Trenching and
Limited Field Investigation Report
Site 7N

Naval Weapons Station Yorktown
Cheatham Annex Site

Response to Comments
Draft Trenching Letter Report
Site 7N
Naval Weapons Station Yorktown, Cheatham Annex Site
Williamsburg, Virginia

FIGURE 5
REVISED WASTE BOUNDARY
5/28/04
SITE 7N

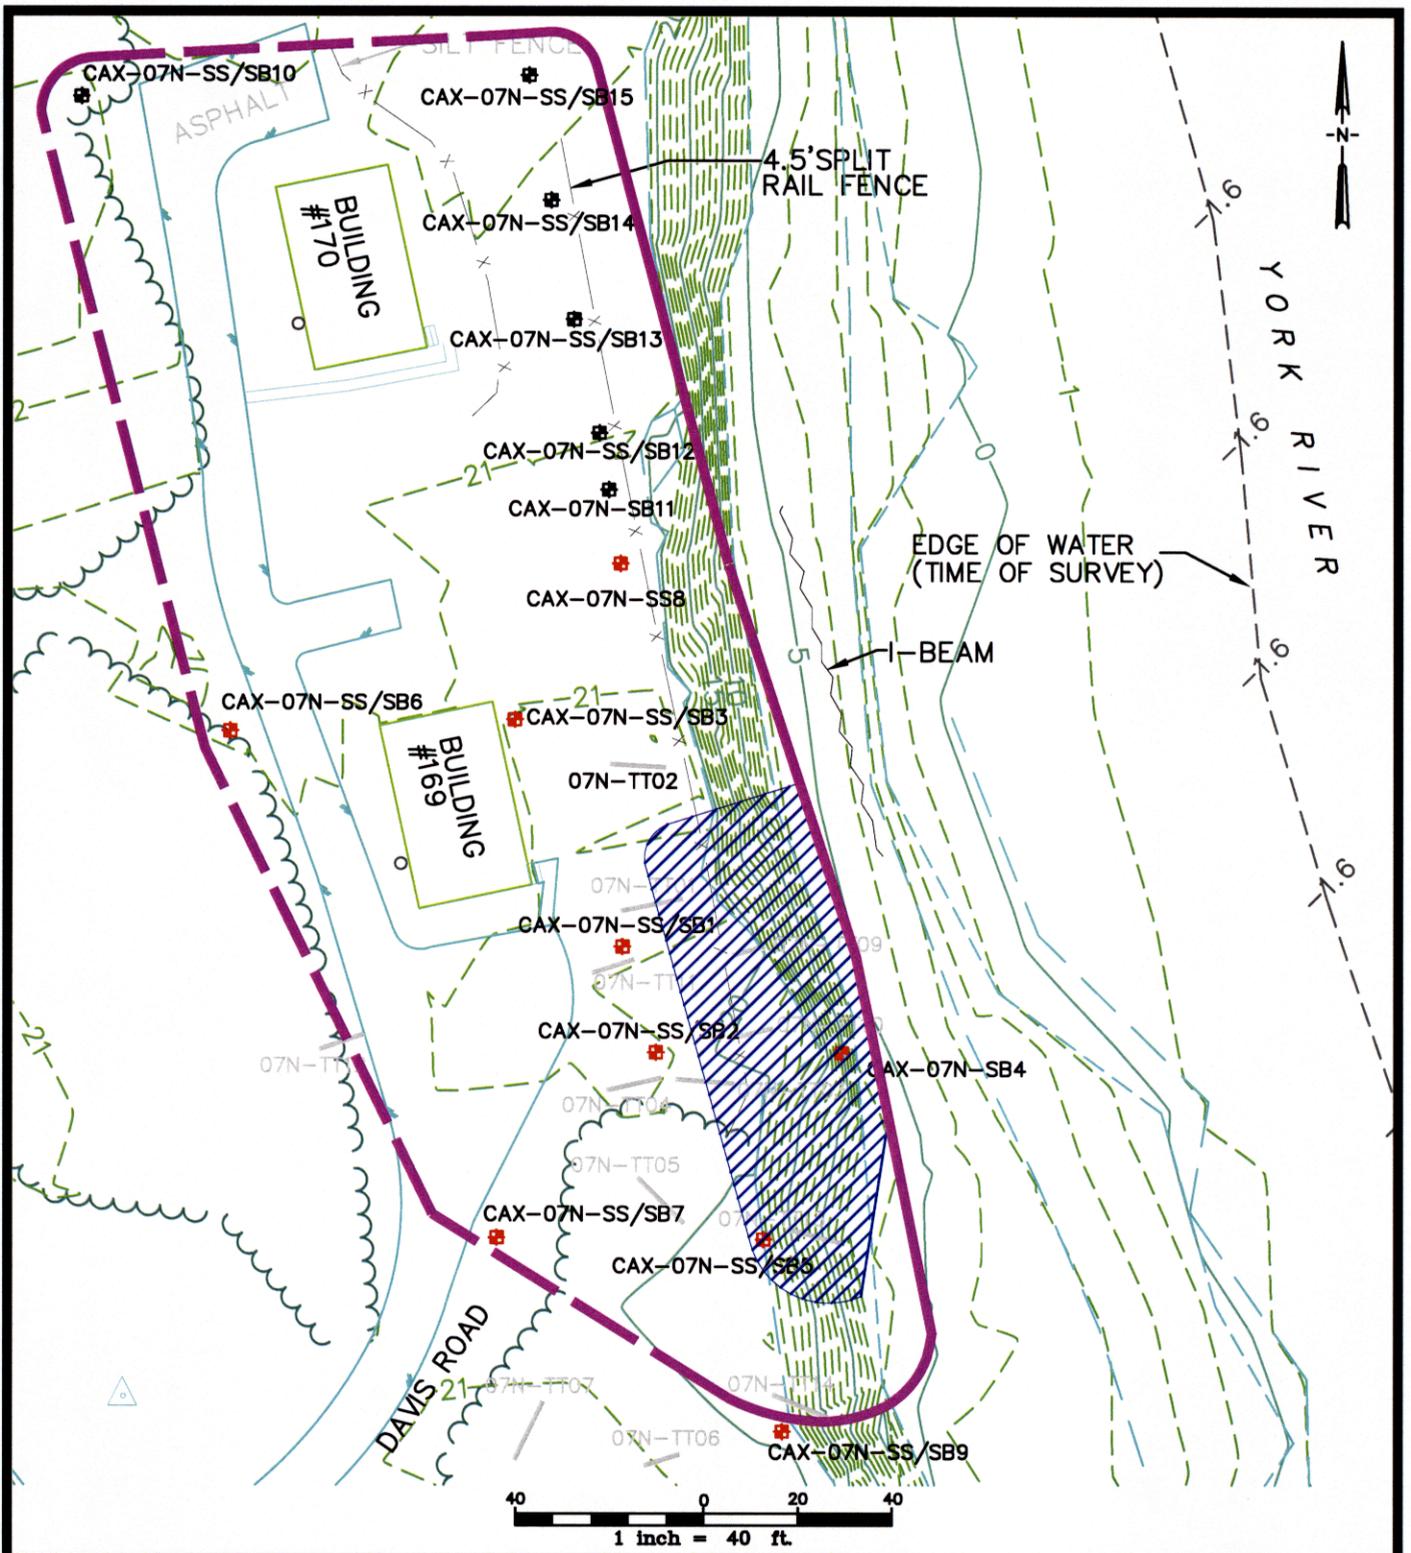
6. **Comment:** Page 8, 3rd paragraph, 2nd bullet. See comment about boundary line on Figure 5.

8. **Comment:** Figure 5. If SS9 is clean then the green line should be north of the sample.

8. Figure 5. If SS9 is clean then the green line should be north of the sample.
9. Figure 6. The drop-off is much steeper, i.e., the distance horizontally is not as great as depicted. A' is shown to the right of SB4 in Figure 5. Are you saying that the debris goes beyond Figure 5 boundary? Recommend having this figure reviewed by a mechanical or civil engineer who can provide guidance on using drawing sections and details.

Response: The Figure 5 comment states that the green (i.e., clean) line should be north of sample SS9 since SS9 defines the clean southeast boundary. Agreed. Figure 5 has been revised.

Response: Agreed. See also response to Comment 6 above.
